Office Action Summary	Application No. 10/562,334	Applicant(s) HUET, JEAN-MAX	
	Examiner LAURA A. BOUCHELLE	Art Unit 3763

DETAILED ACTION

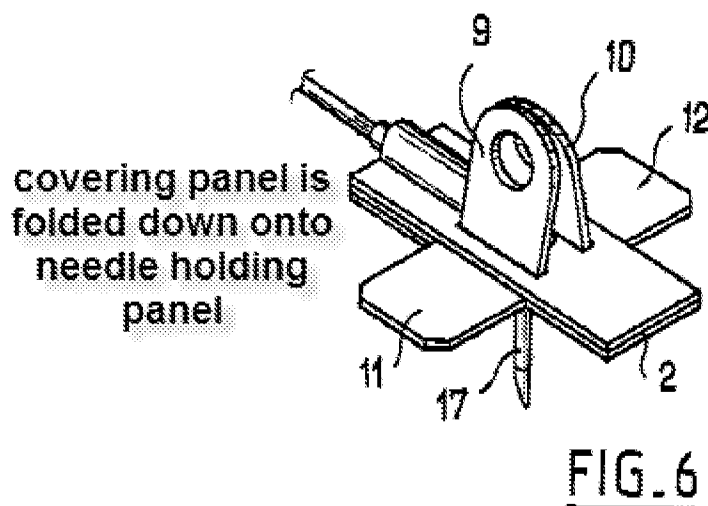
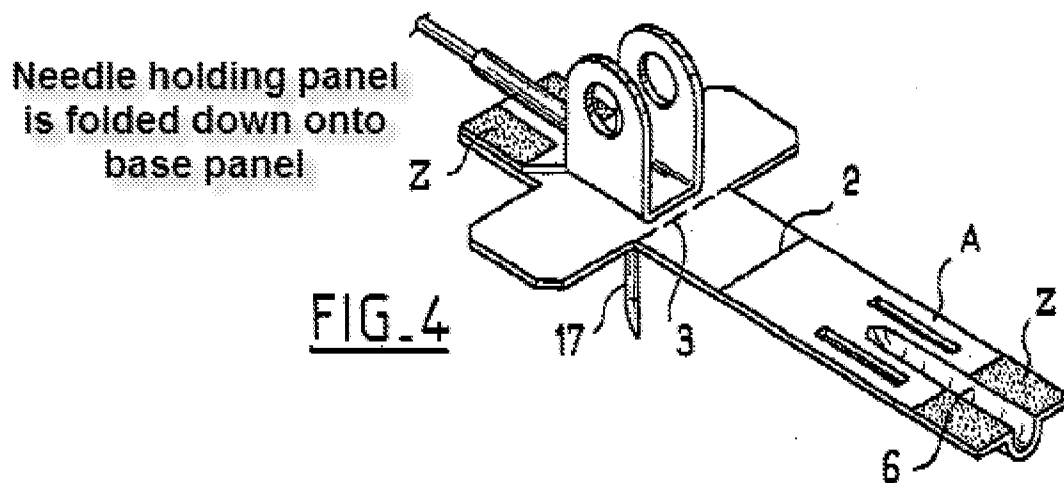
12. The needle being bent and having a perforating distal branch 17 and a proximal feed branch 18 which forms a bend with the perforating branch (see Fig. 1), said device comprising a needle-holding panel F, a base panel D, and a covering panel A forming a wall. See Fig. 1 annotated and included below.

13. Said panels allowing said wall to be brought into a configuration in which said needle-holding panel is folded down onto said base panel (Fig. 2) and in which said covering panel is folded down onto said needle-holding panel and fixed thereto (Figs. 5, 6, the panel is fixed by the lugs 9, 10 protruding through slots A, shown in Fig. 4). Figs. 4 and 6 are included and labeled below.

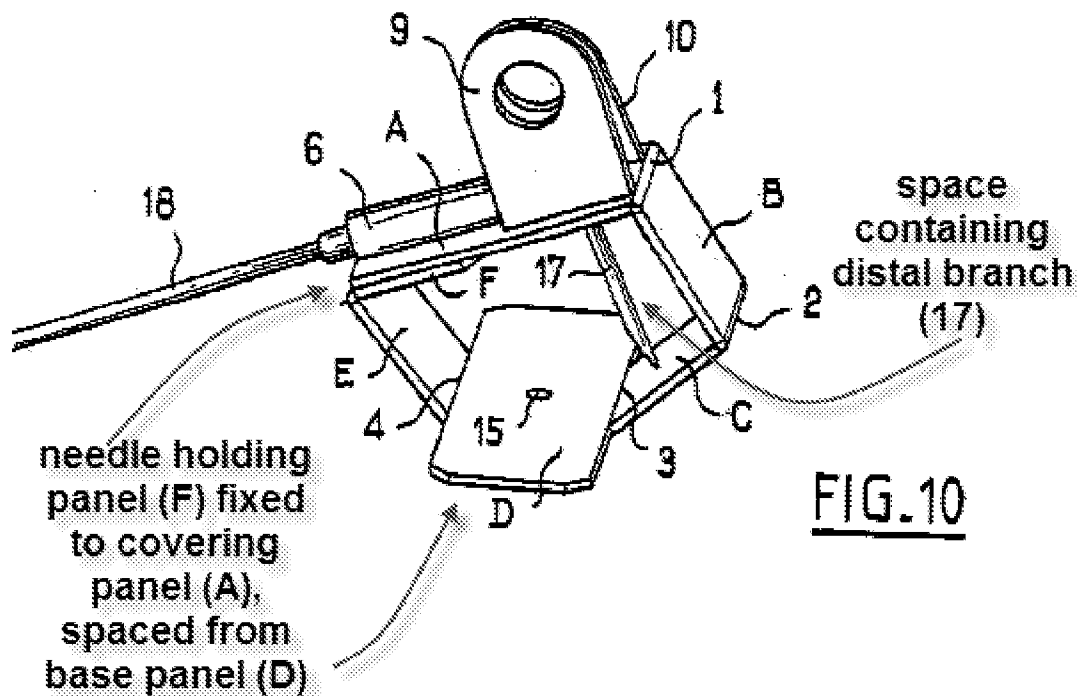
14. The panels can be brought into a configuration in which said needle-holding panel F and said covering panel A are fixed to one another and are spaced from said base panel D and form, between themselves and said base panel, a space which is sufficient to contain said distal branch 17 of said needle. See Fig. 10, annotated and included below.
